Groundwater & Wastewater Services
Septic Project File & Data Review Worksheet

GWS File #: 7925 B WASPS App #: 3079

SKETCH PLAN OF:
RANSON RD MINOR SUBDIVISION
HUNTERSVILLE, MECKLENBURG CO., NORTH CAROLINA

IMPROVEMENT PERMIT for a RESIDENTIAL ON-SITE WASTEWATER TREATMENT & DISPOSAL SYSTEM

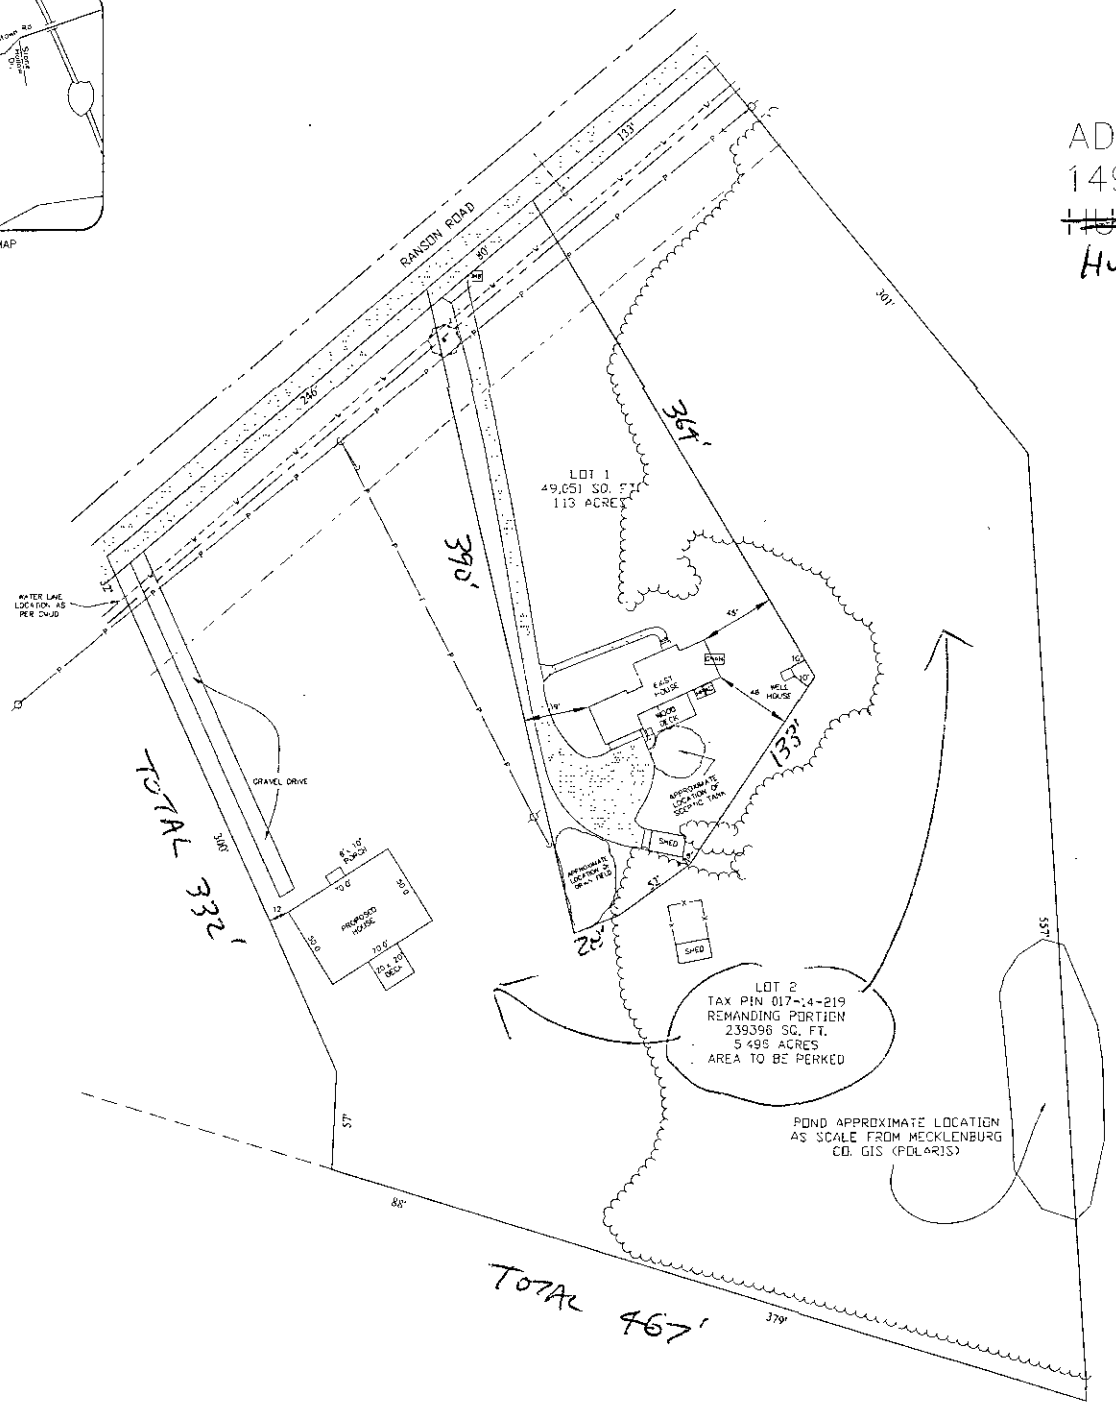
Put Borings on plot
Add Well location on plot
tie in house
Trench depth 28"

SKETCH PLAN OF:
RANSON RD MINOR SUBDIVISION
HUNTERSVILLE, MECKLENBURG CO., NORTH CAROLINA

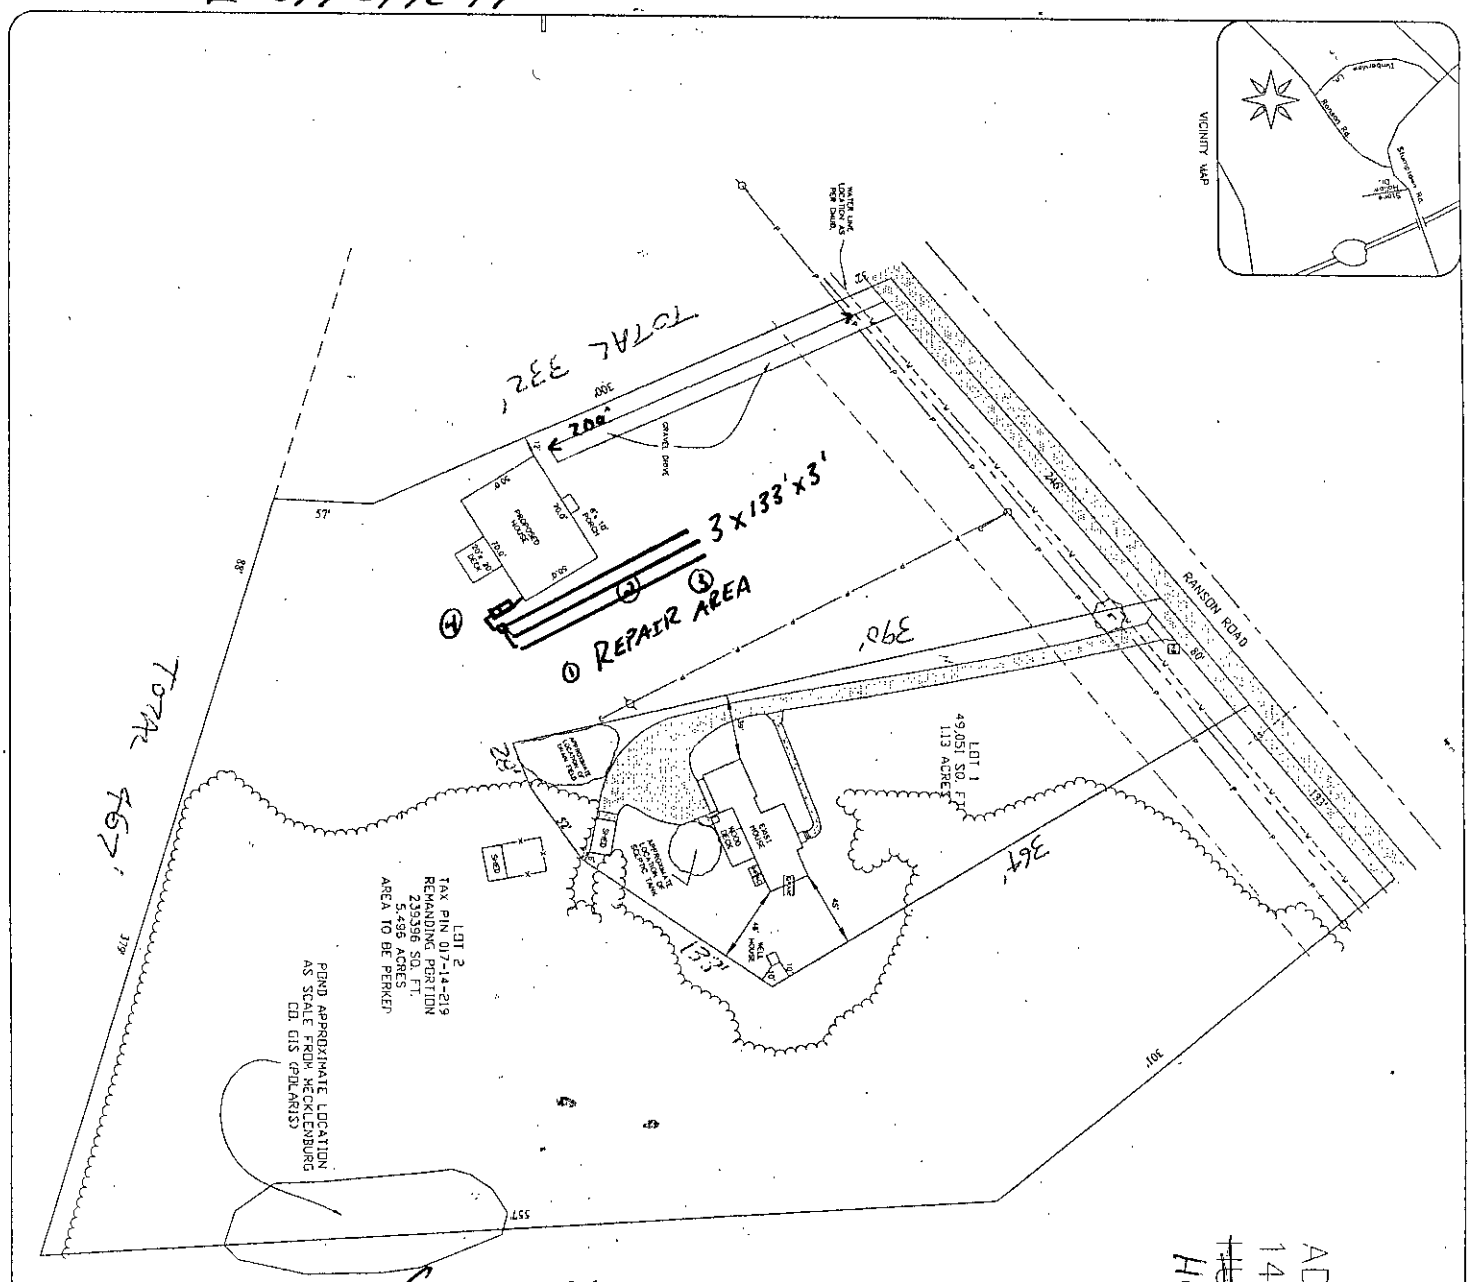
- FOUR BEDROOM HOUSE
- 1500 SEPTIC TANK
- 400 TLF
- 3 LINES x 133' x 3'
- TYPE III @ 25% REDUCTION SYSTEM & REPAIR
